MODIFICATION SHEET No. RDSO/ 2008 /EL/MS/0362 Rev.' 0 ', Dated 24/4/08

1.0 **Title :** Modification in unmodified 1000Amps reverser^{/CTF} servo motor to avoid breakage of fork, roller bush and shaft

FIG. 1

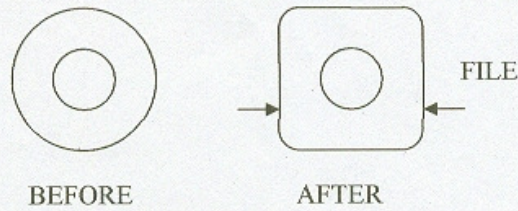
i) For changing the tube, the two sides of the projected portion of the tube is required to be filed such that it can be gripped by pliers.

FIG. 2

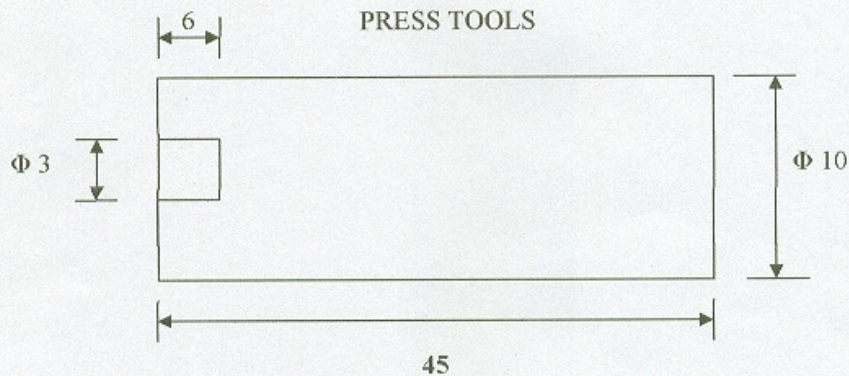
- iii) Then the existing tube is to be pulled out by twisting with plier.
- iv) The following press tool should be used for pressing in outlet tube of 2mm dia in the servomotor.
